Mr. Gary Miller
Remedial Project Manager
San Jacinto River Waste Pits Superfund Site
U.S. Environmental Protection Agency
1445 Ross Avenue, Suite 1200
Dallas, Texas 75202-2733

RE: Comments on Army Corps of Engineers August 2015 Draft Final Evaluation of SJWP FS Remedial Alternatives

Figure 1.

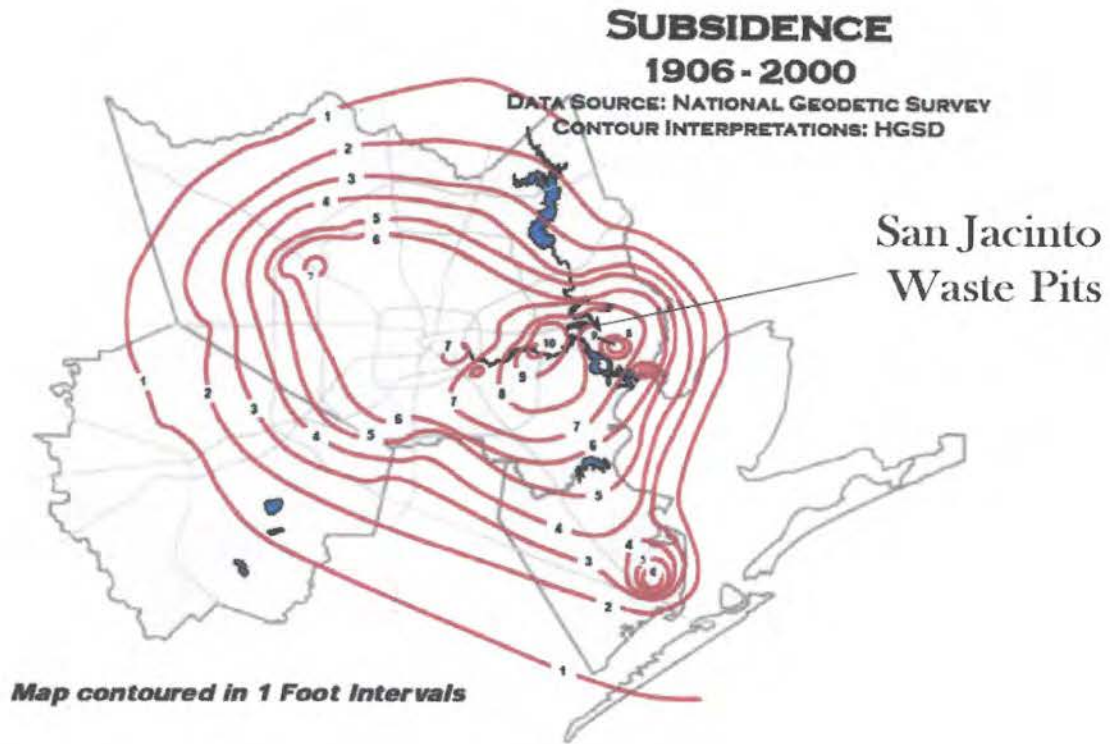
Admittedly, subsidence has effected the Waste Pits in the past, and we cannot know for certain how much the land will subside in the future. What we do know for certain is that local populations and industrial businesses continue to grow which leads to increased extraction of groundwater. Most municipalities use a minimum of 20% groundwater and there are over 1,000 privately owned groundwater wells within five miles of the Waste Pits. See Figures 1 & 2.
